ADDENDUM #2 REBID

Date: June 26, 2025
Re: Connor School Renovations
Connor Consolidated School
1581 Van Buren Road, Connor Township, Maine

Owner Project No: 3403

This Addendum consists of **three (3)** pages and is being issued for revised drawings and clarification.

1 ENLARGED ENTRY AREA
SCALE: 1/4" = 1'-0"

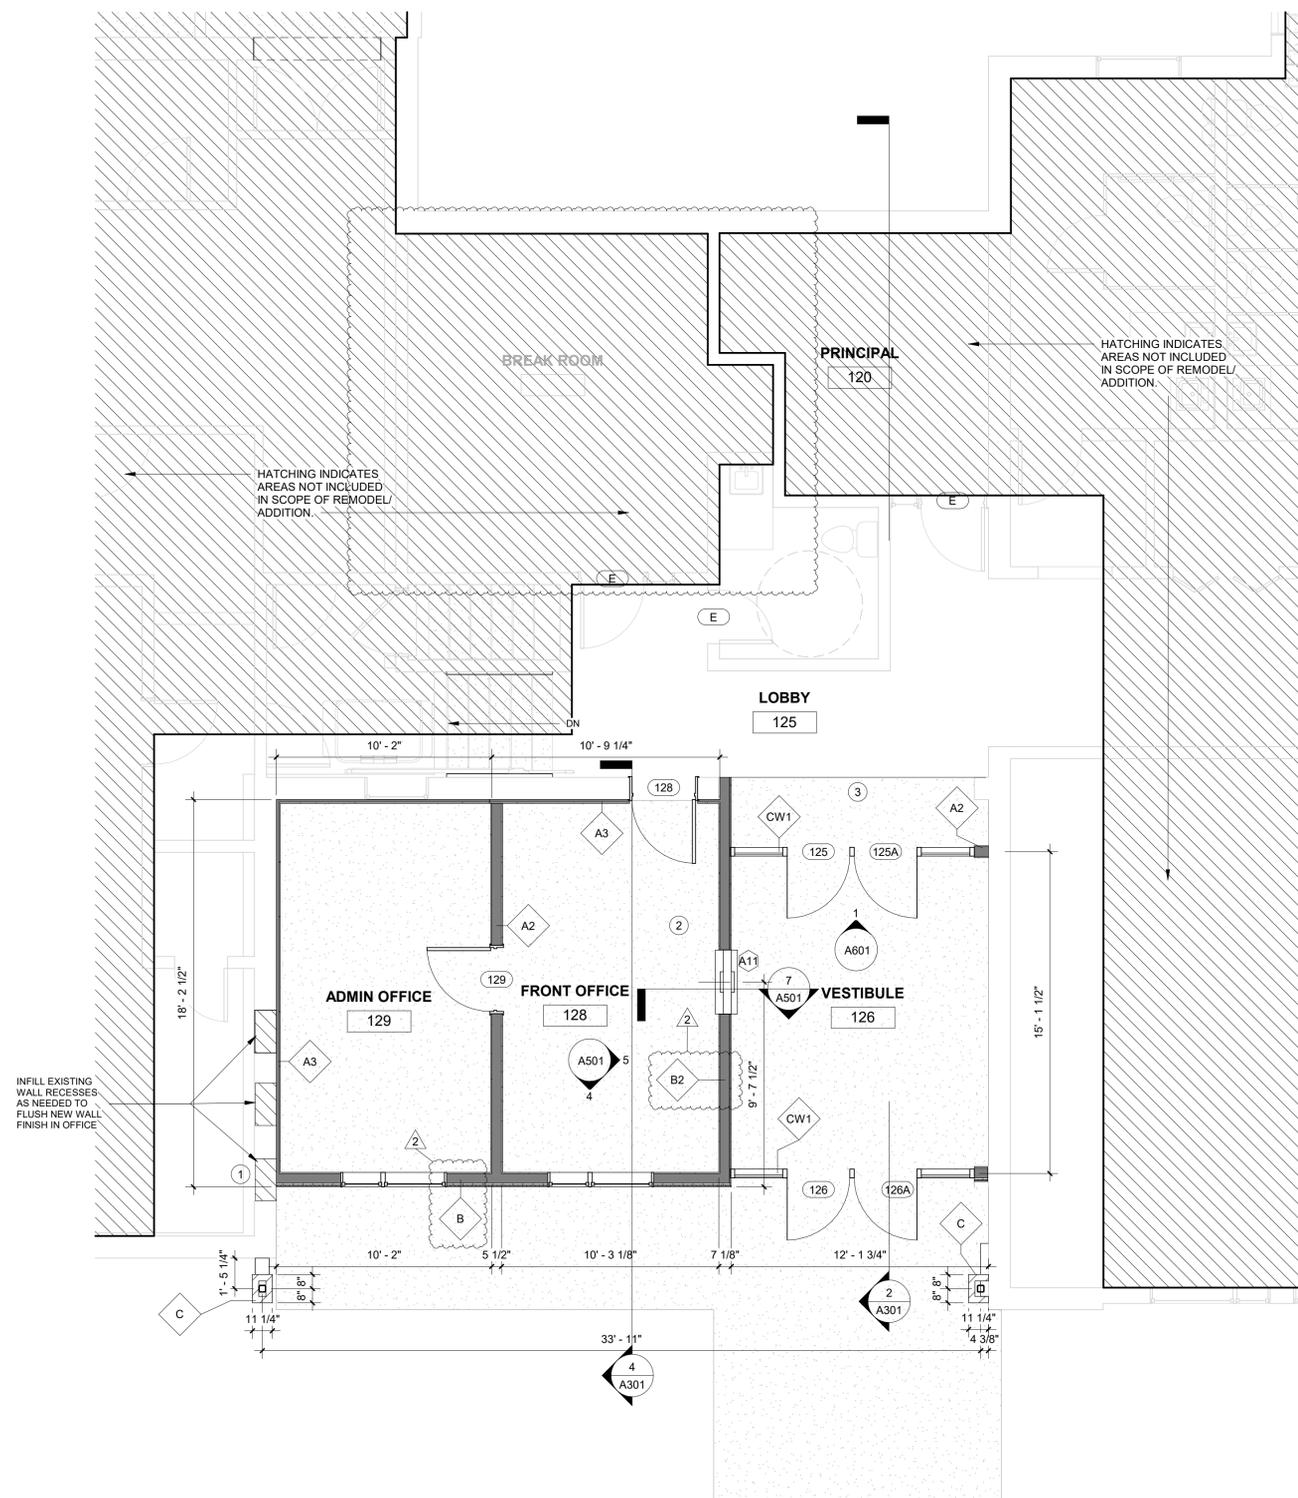
1. *Do we have an automatic ADA door opener at the entrance? **This project does not have an ADA door opener at the entrance.***
2. *The finish schedule has Rooms 128 and 129 scheduled for carpet but we do not see a spec listed on the drawings or in the project. **Please see spec section 09 65 00, flooring to be VCT.***
3. *Drawing A401 partition types do not match with A003 partition types. **Please see revised attached drawings.***
